ADDENDUM NO. 1

Issued: 10.20.2023

Project: Liberty Distribution Center
1142 Southview Dr.

Project No. 23021

CODE FLOOR PLAN - LEVEL 1 BLDG 1

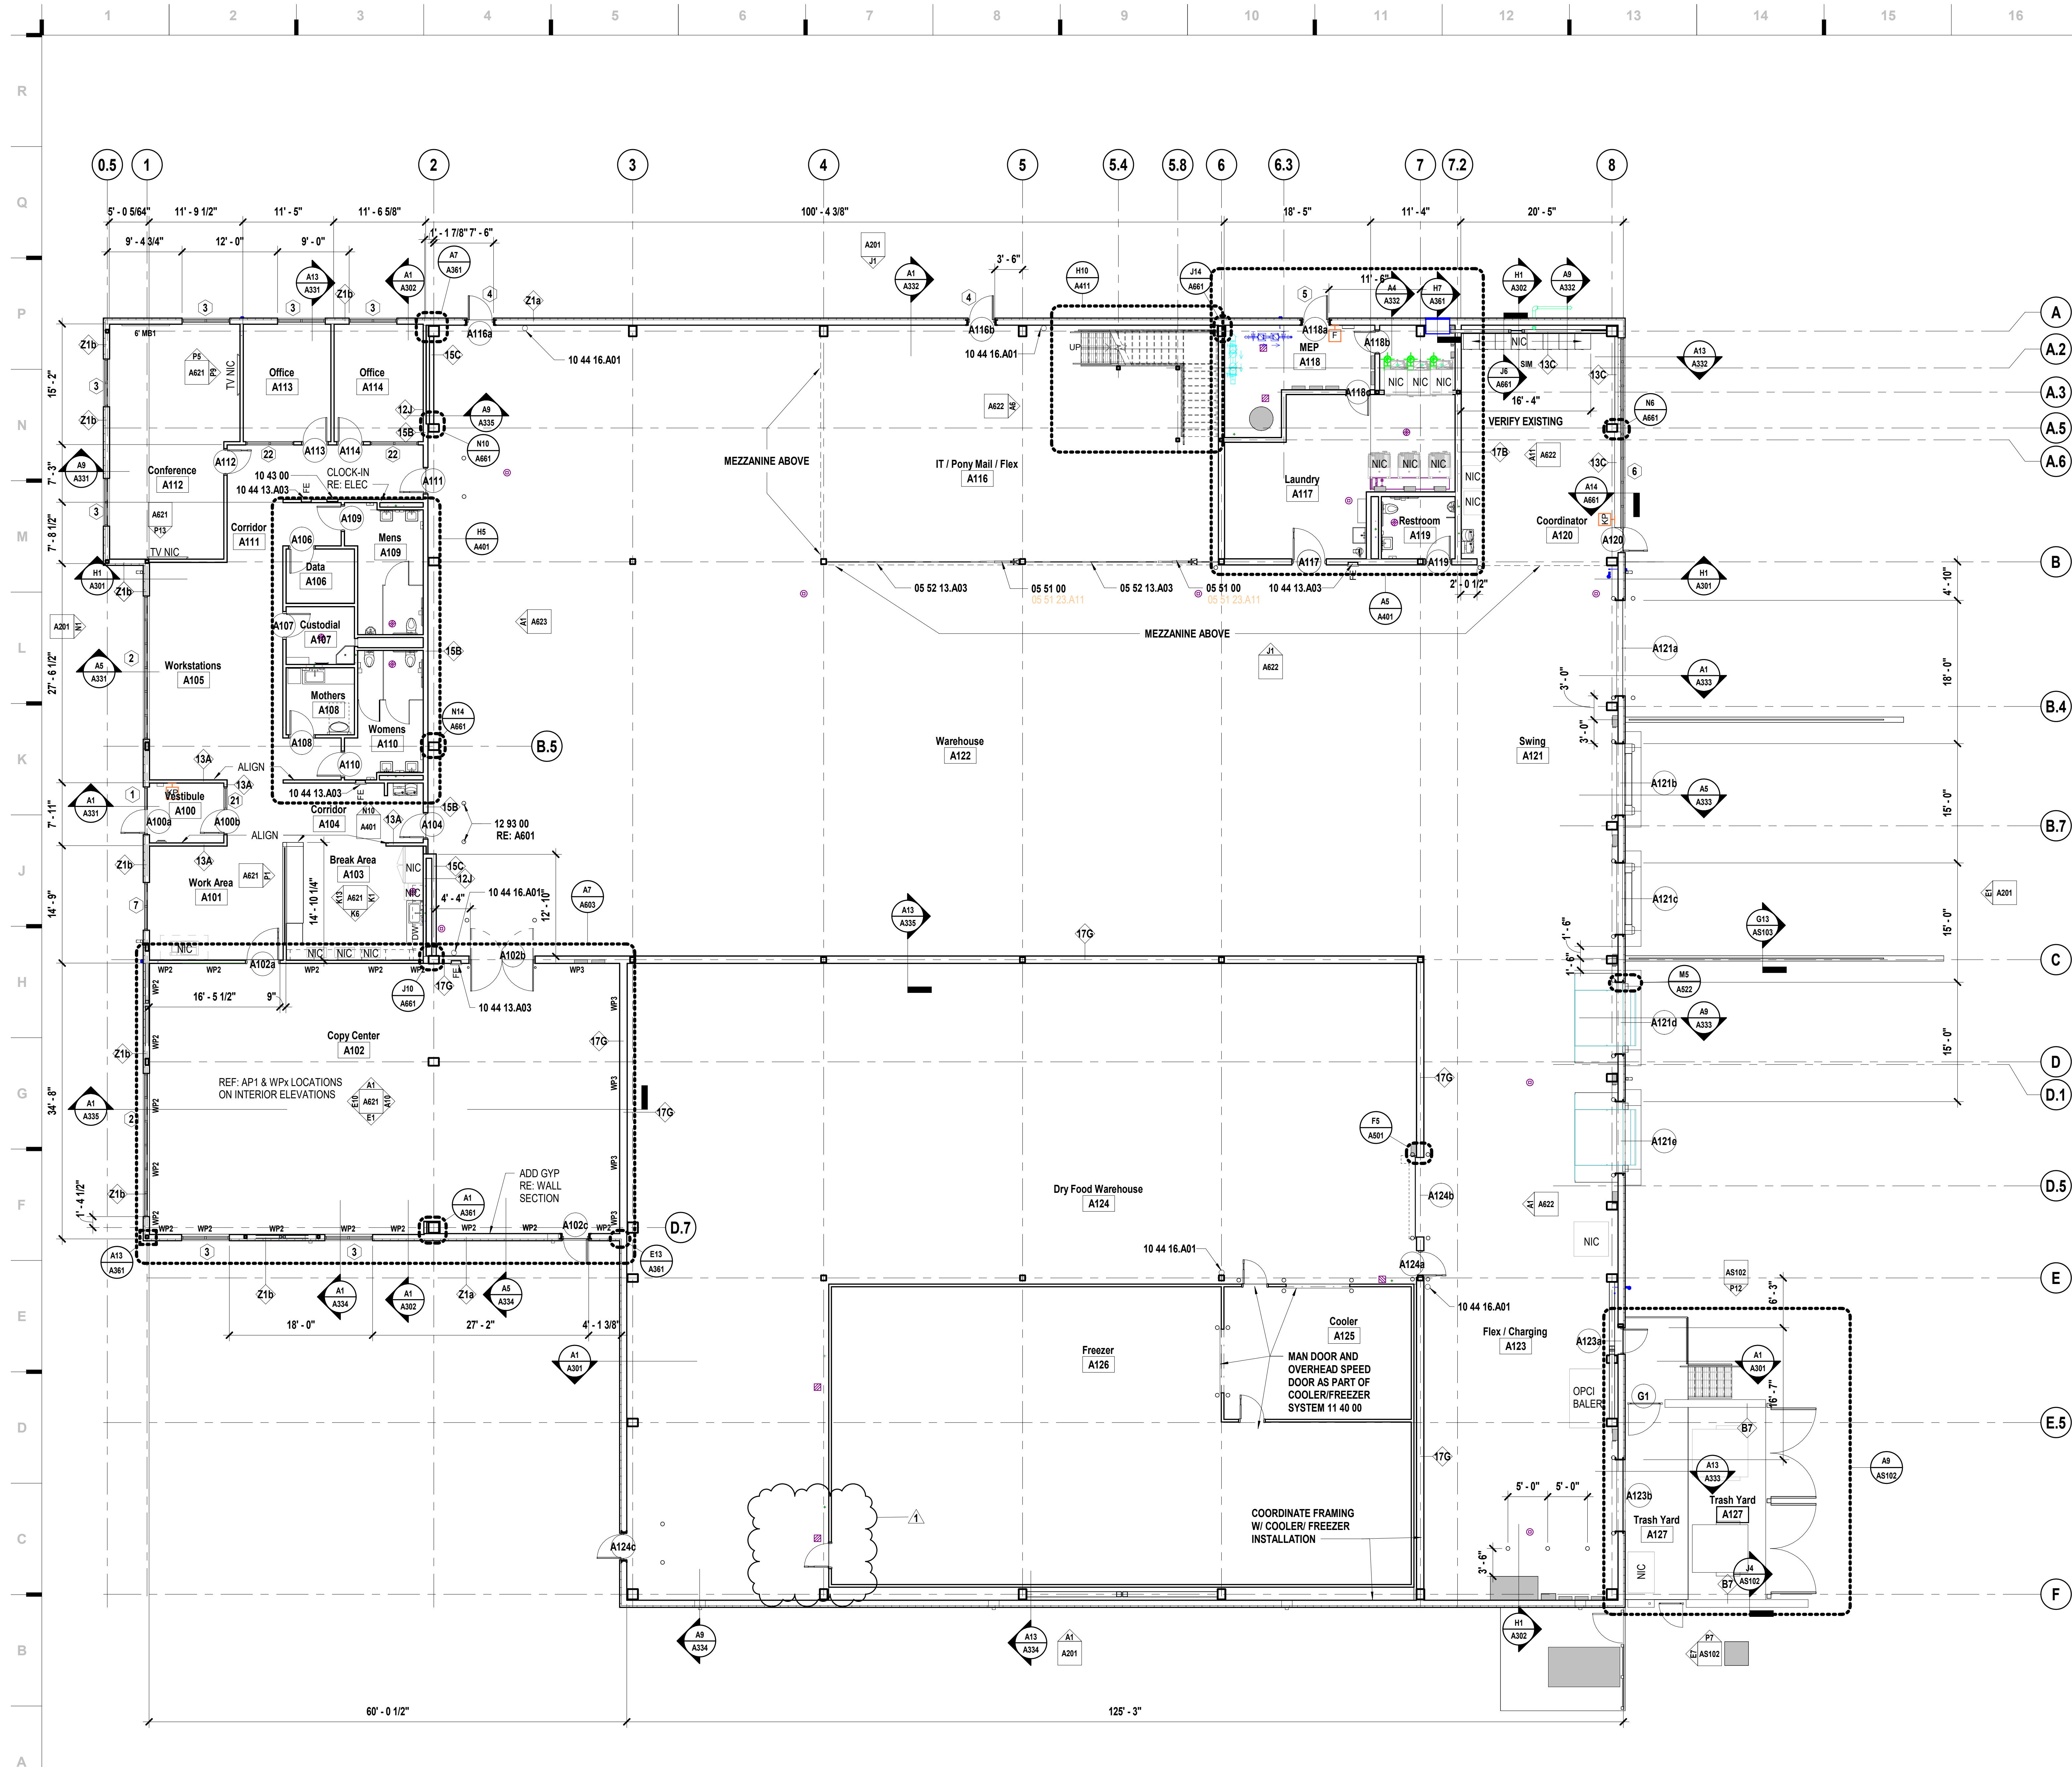
- A8.1 REVISED Code Plan Indicating the location of fire access doors.

A604

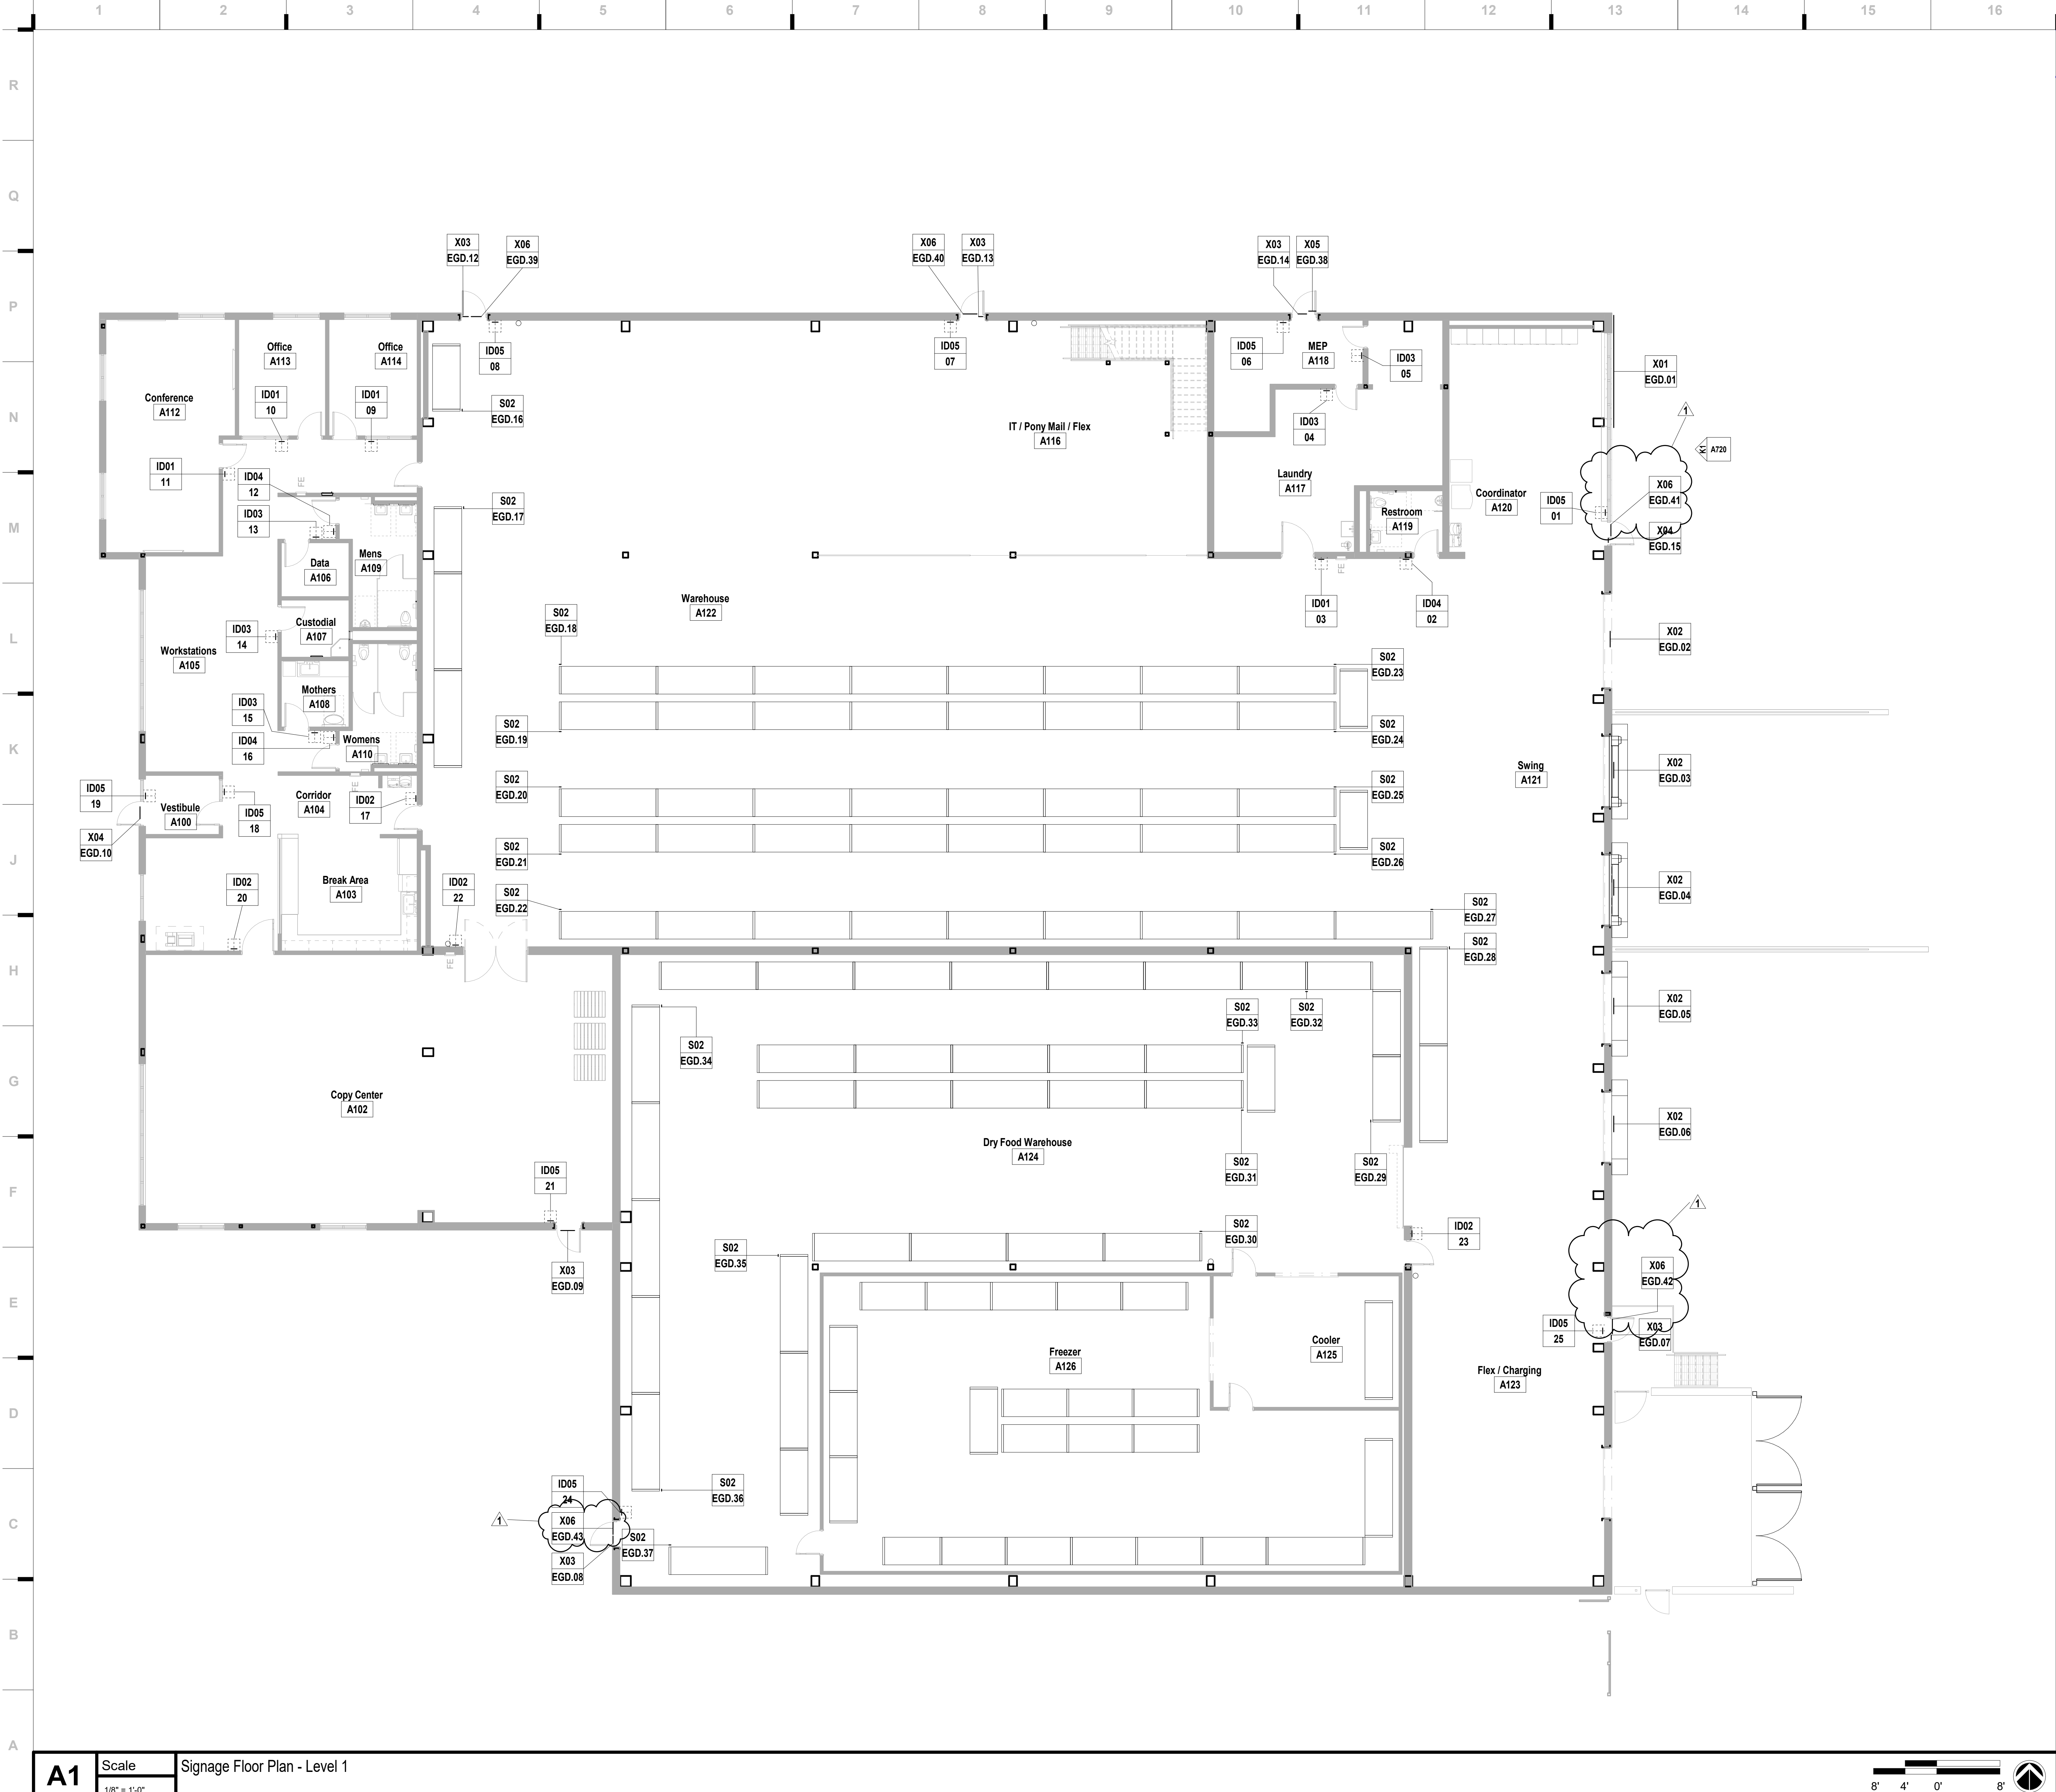
- A10.1 REVISED drawing A1 racking plan to show added door to freezer.
- A10.2 REVISED drawing A1 racking plan to show 2 narrower storage racks adjacent to the added door.
- A10.3 REVISED dimensions on drawing A1 racking plan due to narrower racks.

C110

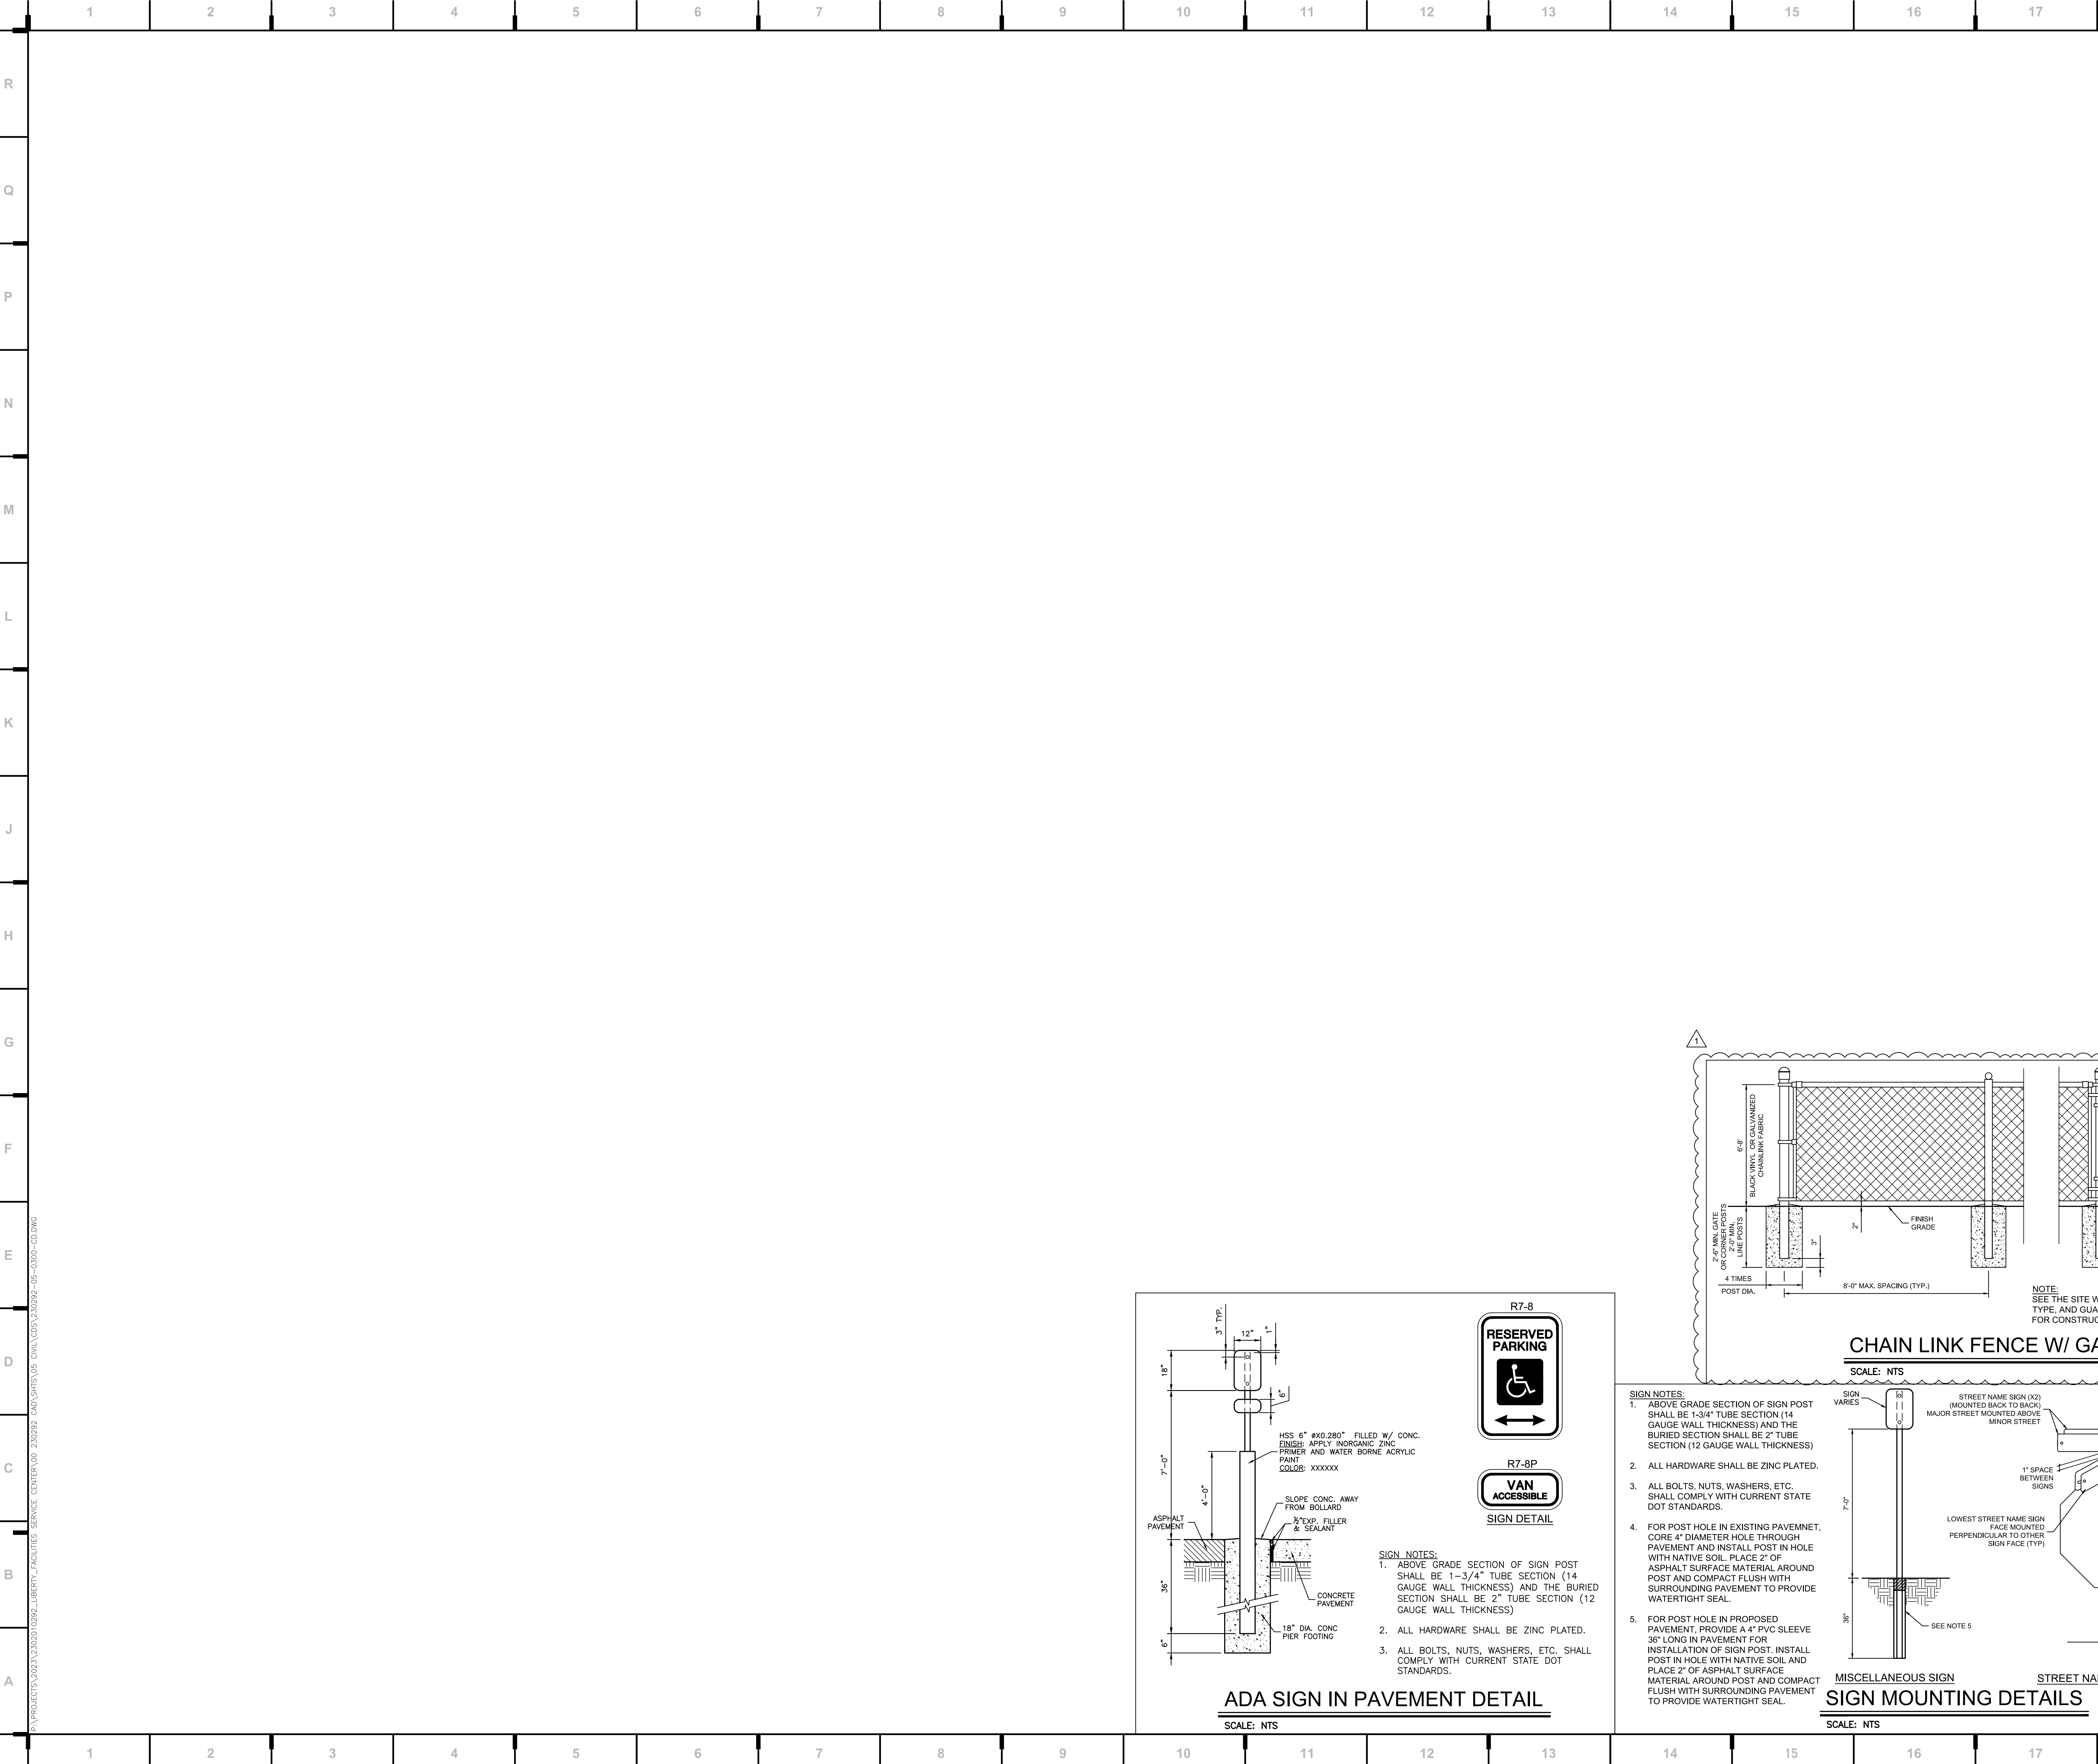
- C109:
 - Added perimeter fence and gates to plan, providing notes with fence information.
- C110:
 - Added perimeter fence and gates to plan, providing notes with fence information.
- C112:
 - Added additional grading area to plan.
- C114:
 - Added additional grading area to plan. Revised silt fence extents.
- C116:
 - Added storm sewer calculation table per City comment.
- C203:
 - Revised chain link fence w/ gate detail per updated fencing heights and information.
